D/DRC Case

1010 Henderson Street
University Hill Architectural Conservation District
TMS: 11405-18-15

**DESIGN/DEVELOPMENT REVIEW COMMISSION
DESIGN REVIEW DISTRICT
HISTORIC CONSENT AGENDA
EVALUATION SHEET
Case #3**

NATURE OF REQUEST: Request for a Certificate of Design Approval for exterior changes.

1010 Henderson Street – Left side view showing existing 1-story rear addition

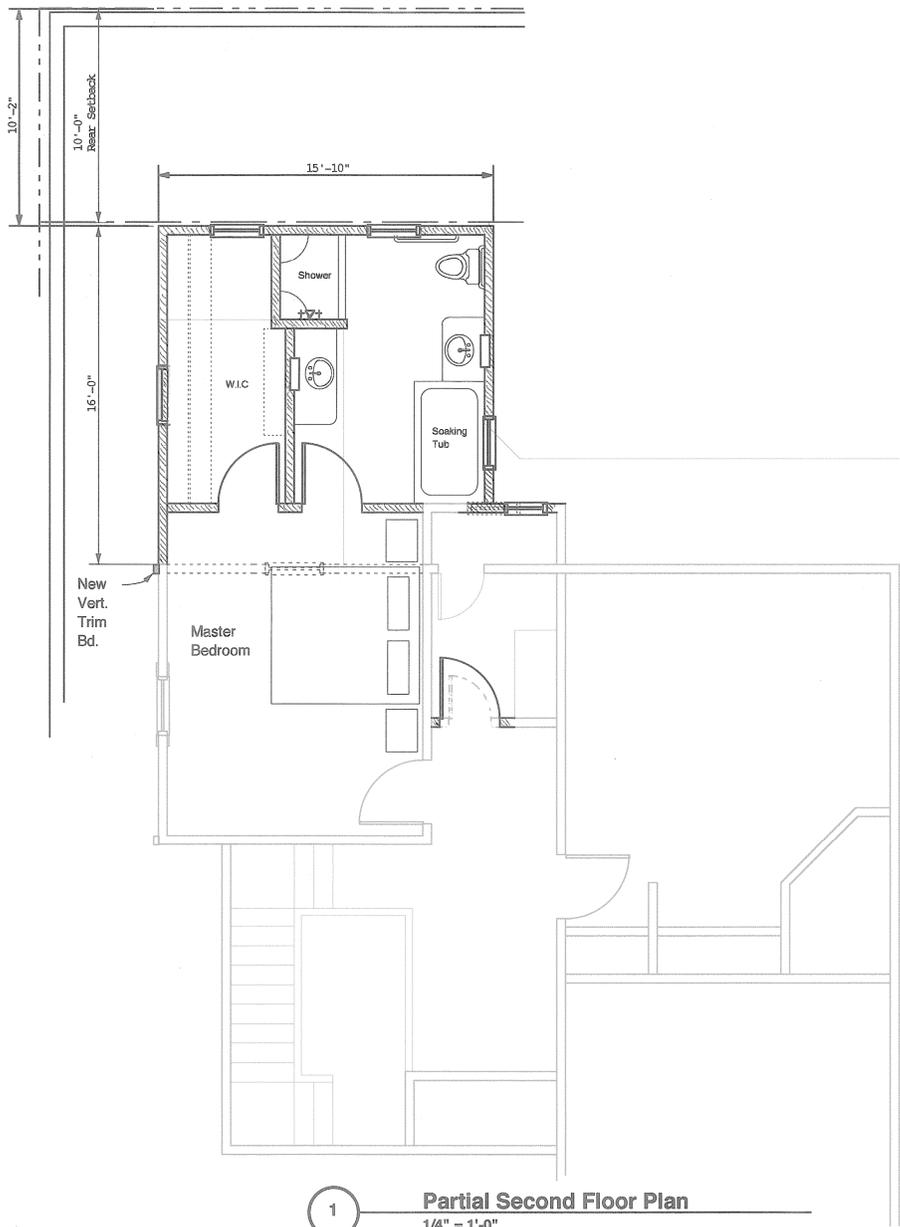
The proposed addition to the rear elevation utilizes architectural elements found throughout the exterior of the building. Therefore, the proposed design does not detract from or obstruct important architectural features. It creates a compatible solution that promotes architectural consistency. The principal façade of the house will not be affected. Staff typically recommends stepping additions in 8"-12" to differentiate the new from the old, but doing so in this case would cause an unusual construction detail for the 2-story addition since it will be placed directly on top of the existing 1-story section of the house.

The essential form and integrity of the house will not be affected by the proposed rear addition. The size and scale of the addition is directly proportional to the gables on the façade and the left side.

Sheet Title: **Partial Floor Plans, Elevations, & Site Plan**

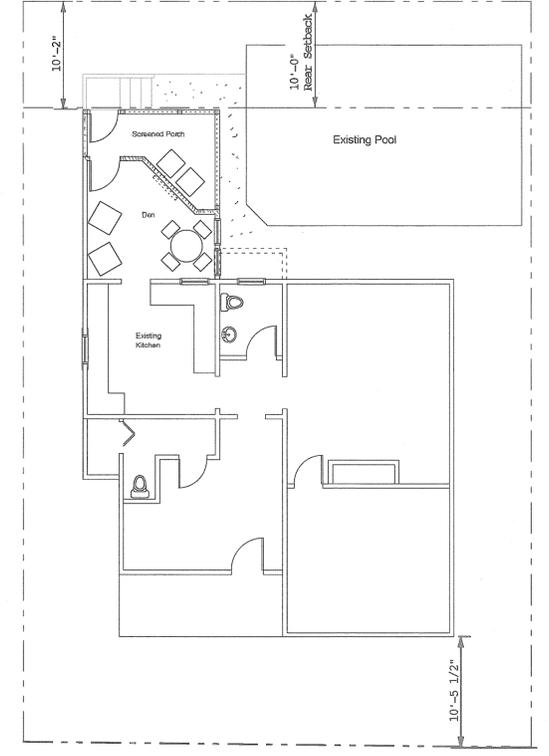
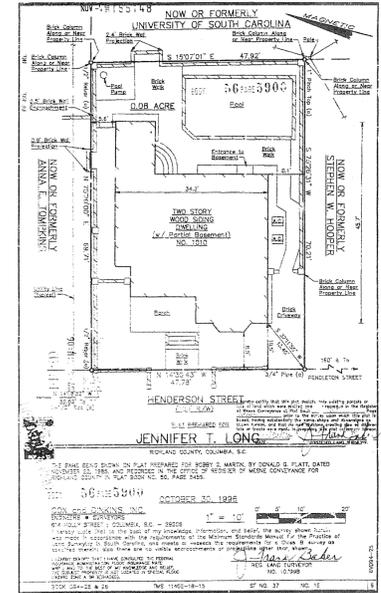
The rhythm of openings on the second floor addition is consistent with the existing fenestration pattern. The proposed opening will be a faux window with permanently closed shutters. This will allow the interior side of the addition to be windowless while being visually compatible with the established rhythm of openings.

The proposed roof shape for the upper portion of the addition will be a gable to match the existing gables on the façade and left sides. Architectural shingles will be used on the addition, which will promote visual consistency with the house.

Staff finds that the proposal complies with the pertinent sections of the guidelines in Section VII – Additions and Section VI – New Construction. ***Staff recommends granting a Certificate of Design Approval for 1010 Henderson Street with the following conditions***

- All details deferred to staff
